Validation report form for post-registration changes for CDM project activities
(Version 01.0)

VALIDATION REPORT ON POST-REGISTRATION CHANGES (PRCs)

Title and reference number of the project activity	K-water hydropower VI
Process track	<input type="checkbox"/> Prior approval <input checked="" type="checkbox"/> Issuance <input type="checkbox"/> Renewal of crediting period
Version number of the validation report on PRCs	Version 02.0
Completion date of the validation report on PRCs	26/05/2017
Type(s) of PRCs	<input type="checkbox"/> Temporary deviations from the registered monitoring plan, monitoring methodology or standardized baseline <input checked="" type="checkbox"/> Corrections <input type="checkbox"/> Changes to the start date of the crediting period <input type="checkbox"/> Inclusion of a monitoring plan to a registered project activity <input checked="" type="checkbox"/> Permanent changes from registered monitoring plan, monitoring methodology or standardized baseline <input type="checkbox"/> Changes to the project design of a registered project activity <input type="checkbox"/> Types of changes specific to afforestation and reforestation project activities

“K-water hydrop

Figure. A previous single-line diagram for Ipo, Gangcheon power plant

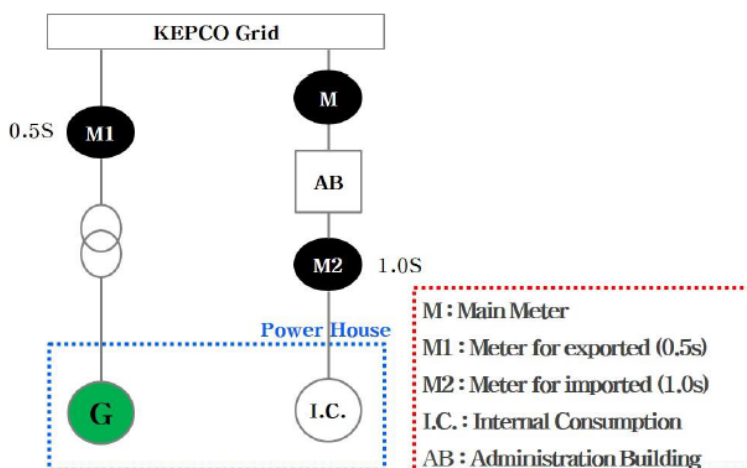
In the case of Ipo and Gangchen hydropower plants, the watt-hour meters for measuring the both amount of electricity exported to the grid and imported from the grid are installed in two lines separately, respectively until 01/12/2016. The main meter for electricity imported from KEPCO grid is installed in the administration building and K-water's meter for power house is located though the administration building as shown below.

The verification team checked the previous single line diagrams^{/12/} showing the location of KEPCO's meter for electricity consumption and internal K-water's meter for imported electricity of power house during the on-site visits.

And it was found that the previous line diagrams^{/12/} described in the registered PDD(ver.04.0) could not represent the actual project activity.

The correction of the single line diagram^{/12/}, related to both Ipo and Gangcheon sites, described in the revised PDD(ver.05.0)^{/02/} is to add the symbols of meter imported from grid and Administration building.

It was confirmed that the correction of this diagram is to represent the actual project design, not to change of the project design.

Therefore, this correction is acceptable.
